Subject: **SOUTHERN CALIFORNIA PUBLIC POWER AUTHORITY'S
SECOND SET OF DATA RESPONSES
DOCKET NO. 07-AFC-9**

CANYON POWER PLANT

**CANYON POWER PLANT
APPLICATION FOR CERTIFICATION
SECOND RESPONSE TO CEC DATA REQUESTS
07-AFC-9**

Project No.: 28906973	Date: OCTOBER 2007
Project: City of Anaheim Public Utilities Proposed Power Generation/ Peaker Site	Figure 1

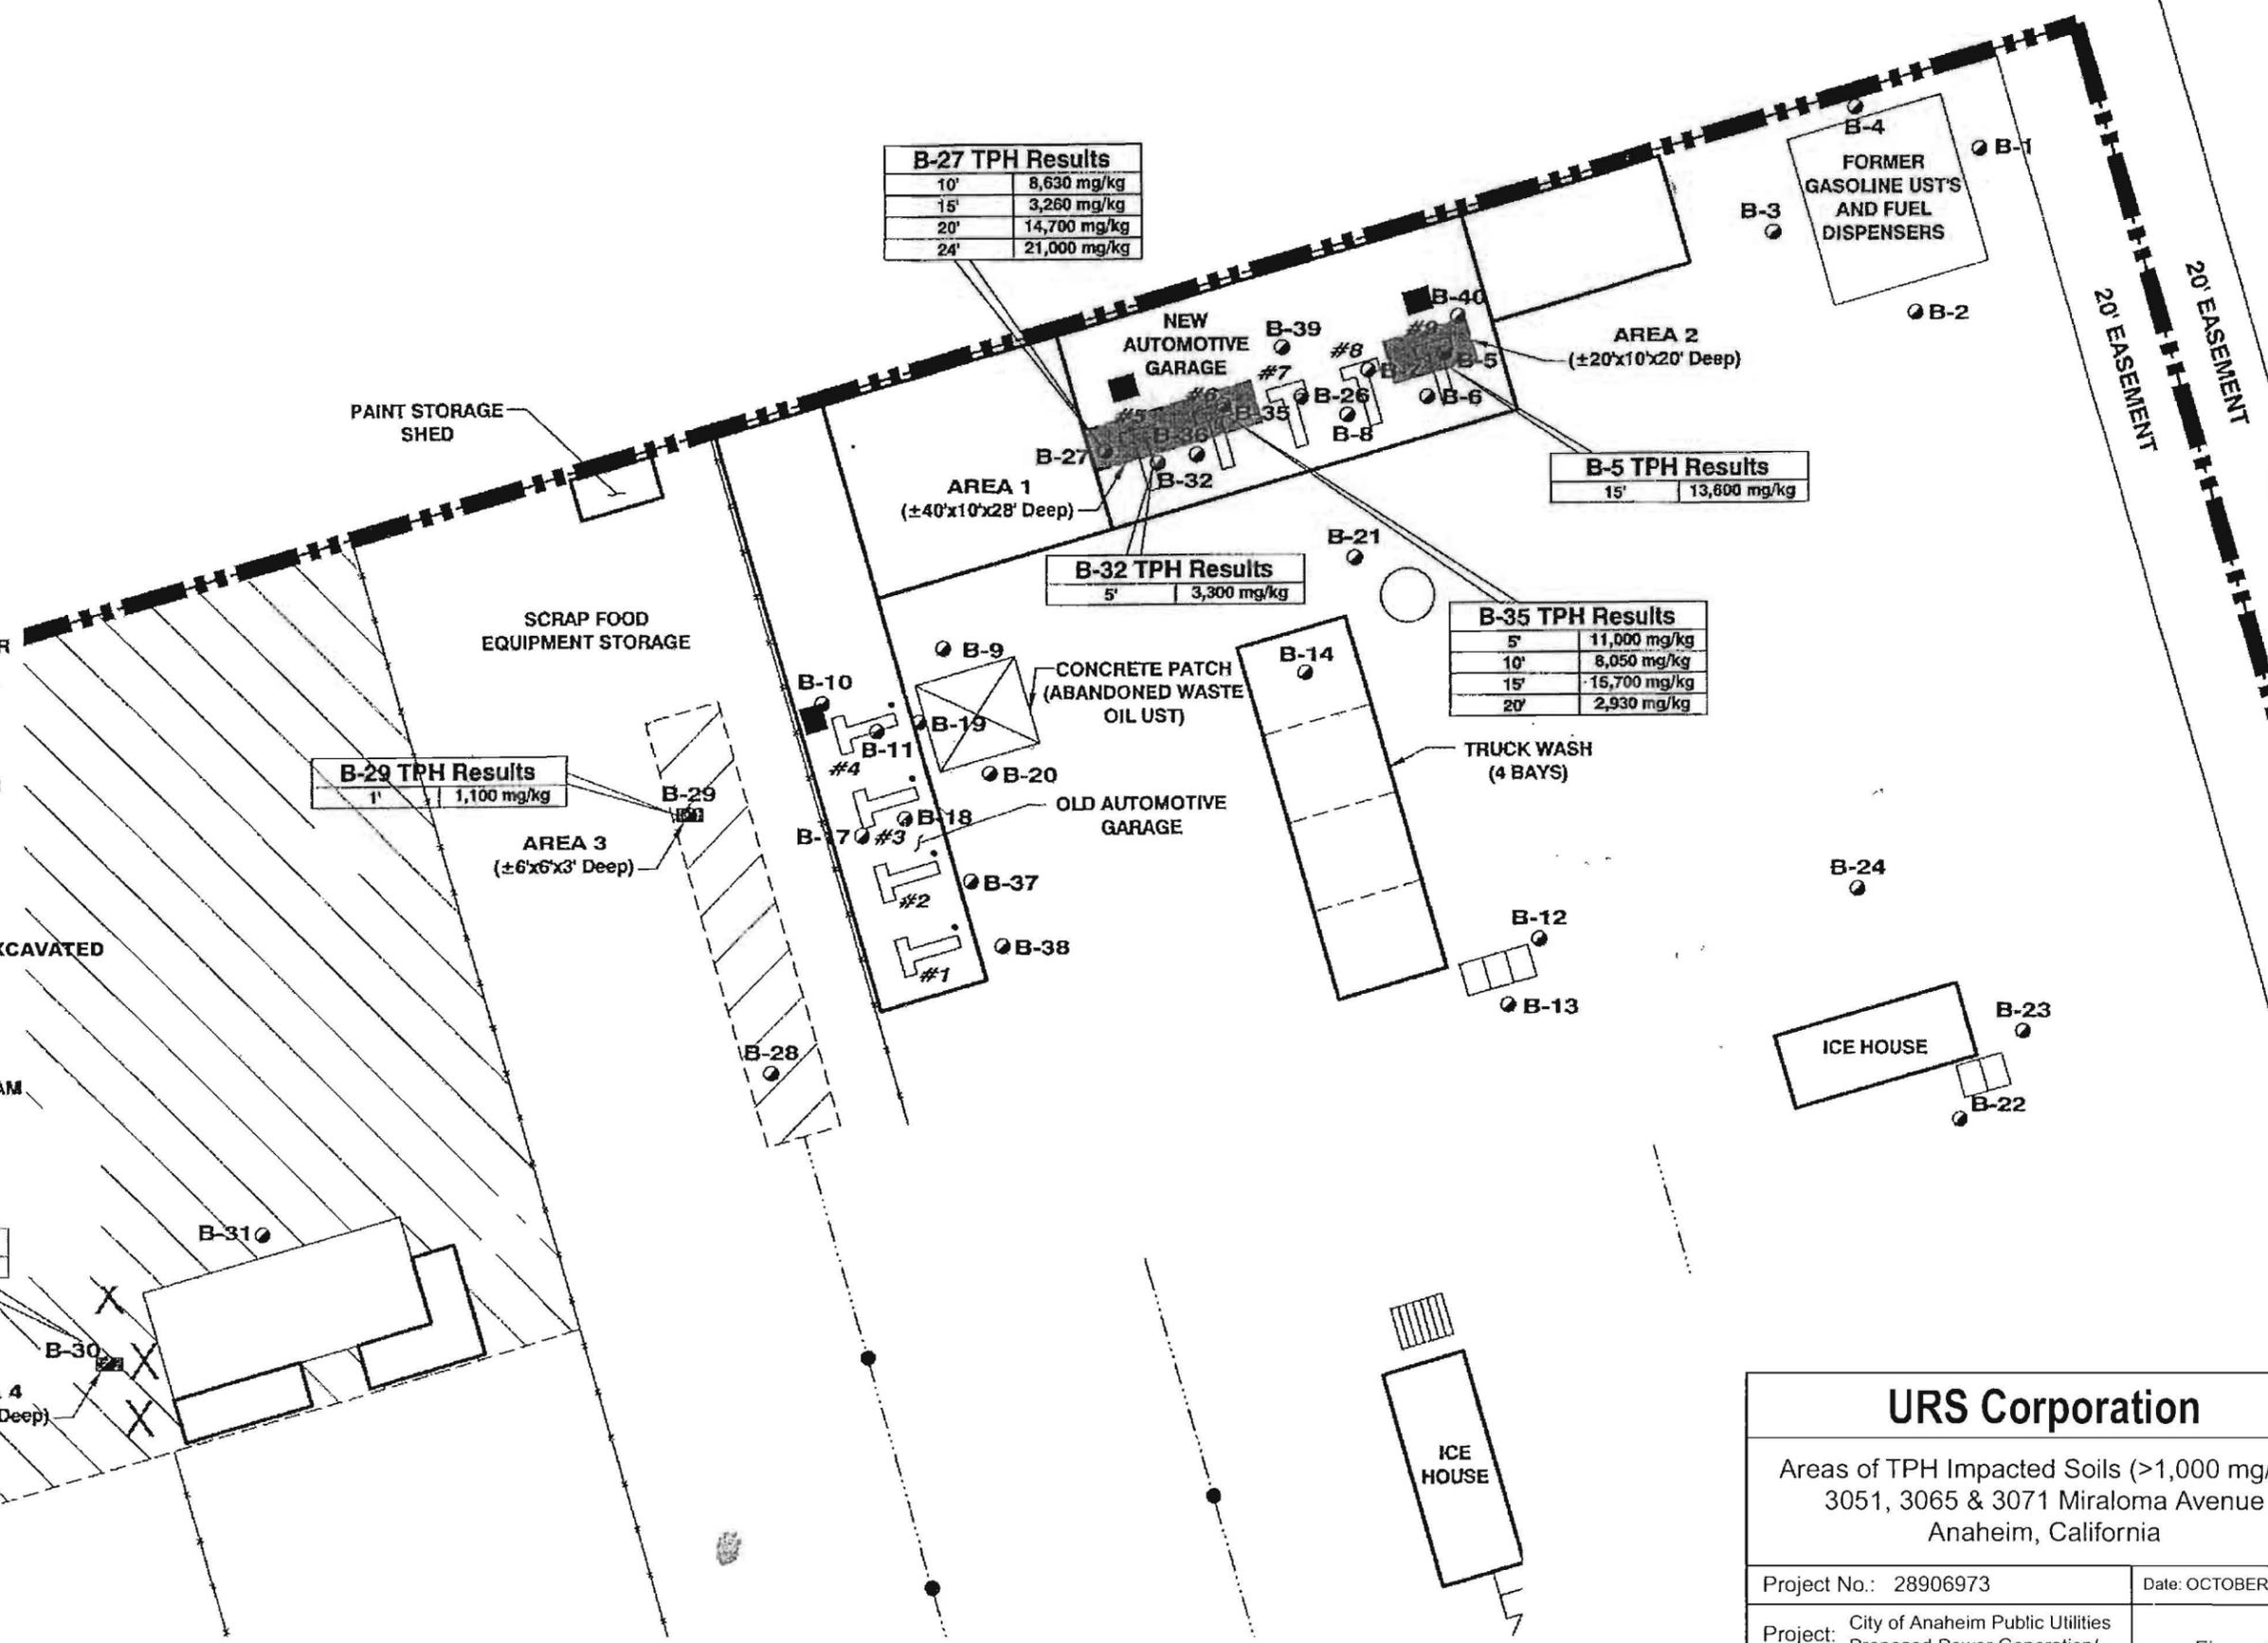
- Background:** On page 19 of the Supplemental Phase I there is discussion of TCE. Also in the AFC, different areas to be excavated are discussed.
- Data Request WASTE-1:** Is there a diagram or figure that shows these specific areas and their contamination? TPHC, SVOCs can easily be remedied with excavation; TCE should be shown to be remedied as well.
- Response:** Please see attached memorandum from URS Task Leader Tariq Hussain.

- **PCBs** – Data indicates there is no impact to soil from PCBs; results were non-detect.
- **TPH-cc** – Data indicates soil is impacted by TPH-cc in the northern area of the site where there were automotive operations and in the northwest corner of the site. Sample locations B-5, B-27, B-29, and B-35 had TPH-cc concentrations that exceeded the generally accepted level of 1,000 mg/kg for TPH heavier-range compounds; see Figure 1.

- **TPH-cc** – As shown on Figure 2, there are three areas recommended for excavation to meet the generally accepted level of 1,000 mg/kg for TPH heavier-range compounds. The previously proposed areas for excavation are still applicable because the supplemental sampling did not identify any additional areas of concern. The Site has been impacted by operations at automotive garages but the Site appears to be free of impact from the historic operations of the abandoned-in-place waste oil UST, former USTs, grease trap UST, truck wash bay, and oil/water separator.
